Source: SK Telecom

Title: Initial synchronization and CR for Initial synchronization of USTS in 25.215

Subject: Measurement of Initial synchronisation time for USTS

Fig. 1. The Initial Synchronization Time

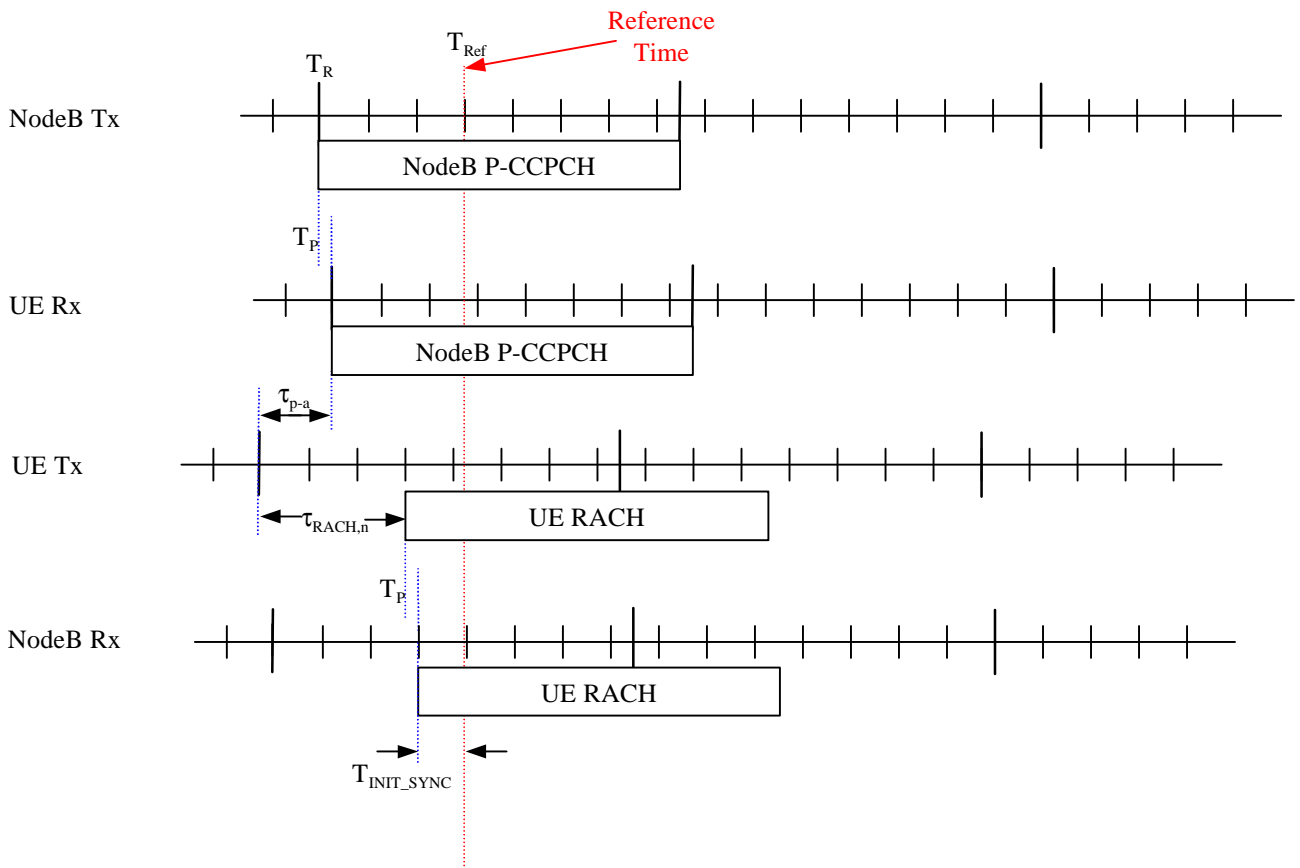
The amount of timing control for initial synchronization ($T_{\text{INIT_SYNC}}$) is equal to the difference in time between the reference time of Node B and the time of reception of RACH as shown in Fig. 1.

- When AICH_Transmission_Timing is set to 0, then $\tau_{p-a} = 7680$ chips
- When AICH_Transmission_Timing is set to 1, then $\tau_{p-a} = 12800$ chips
- $\tau_{RACH,n}$: the difference in time between the start timing of #0 slot and that of selected access slot number

Fig 2. The timing control for Initial Synchronization

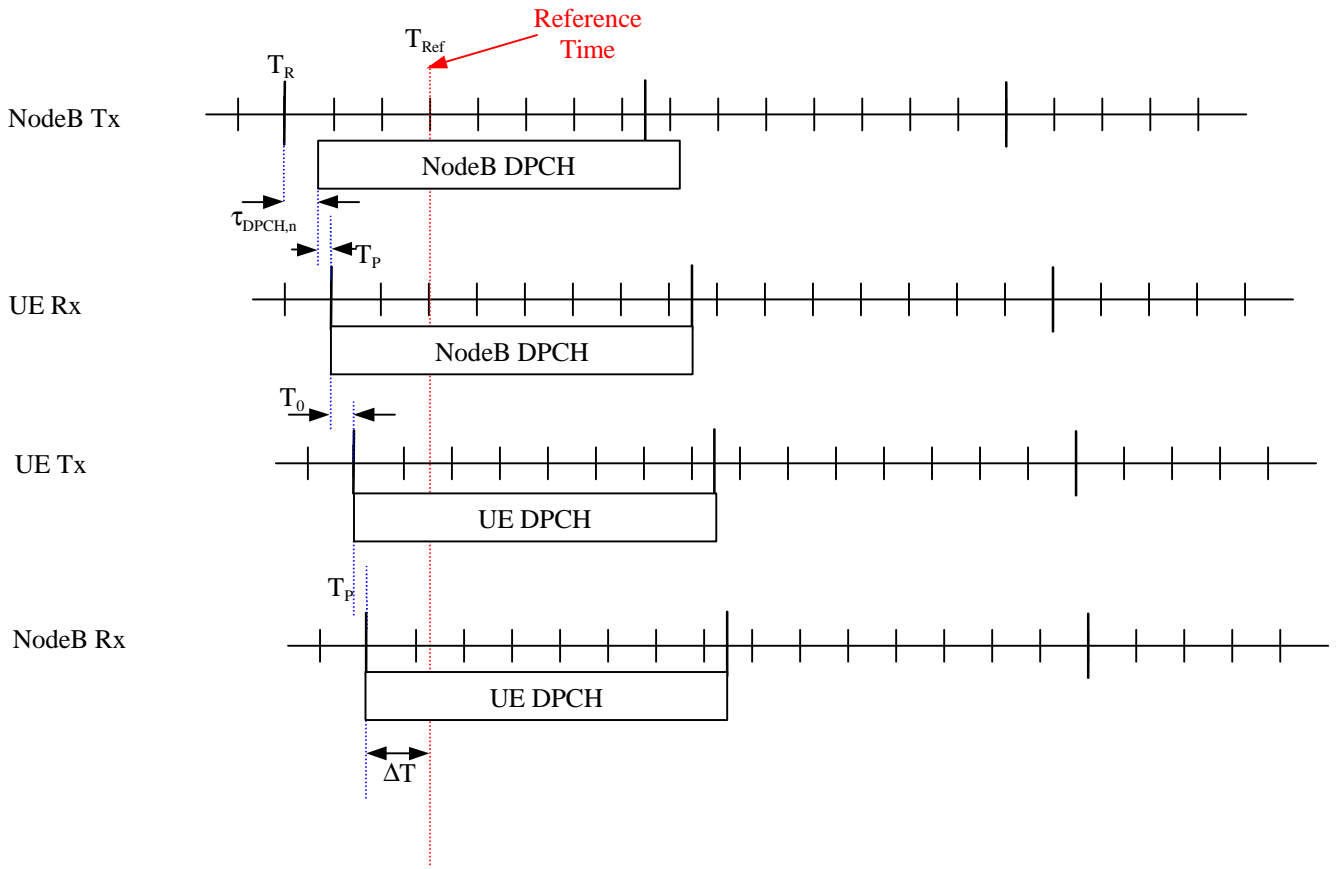
There are several offset times ($\tau_{\text{DPCH},n}$) when Node B transmits DPCHs as shown in Fig. 2. Thus, the timing control for initial synchronization is practically carried out by $T_0 + \Delta T$ as shown in Fig. 2. and this value can be obtained with $T_{\text{INIT_SYNC}}$.

- The DPCH timing may be different for different DPCHs, but the offset from the P-CCPCH frame timing is a multiple of 256 chips, i.e. $\tau_{DPCH,n} = T_n \times 256$ chip, $T_n \in \{0, 1, \dots, 149\}$.
- At the UE, the uplink DPCH/DPDCH frame transmission takes place approximately T_0 chips after the reception of the first significant path of the corresponding downlink DPCH/DPDCH frame. T_0 is a constant defined to be 1024 chips.

$$T_{DPCH,Tx,UE} = T_{DPCH,Rx,UE} + T_0 + \Delta T.$$

If we set $\Delta T = T_{INIT_SYNC}$, then it make the received signals from UEs keep the orthogonality. Therefore the time of transmission of DPCH from UE is

$$T_{DPCH,Tx,UE} = T_{DPCH,Rx,UE} + T_0 + T_{INIT_SYNC}.$$

As a results, the UE sets the reference time ($T_{DPCH,Rx,UE}$) at the time of reception of the beginning of a downlink DPCH frame from Node B and the amount of time offset for initial synchronization is equal to $T_0 + T_{INIT_SYNC}$.
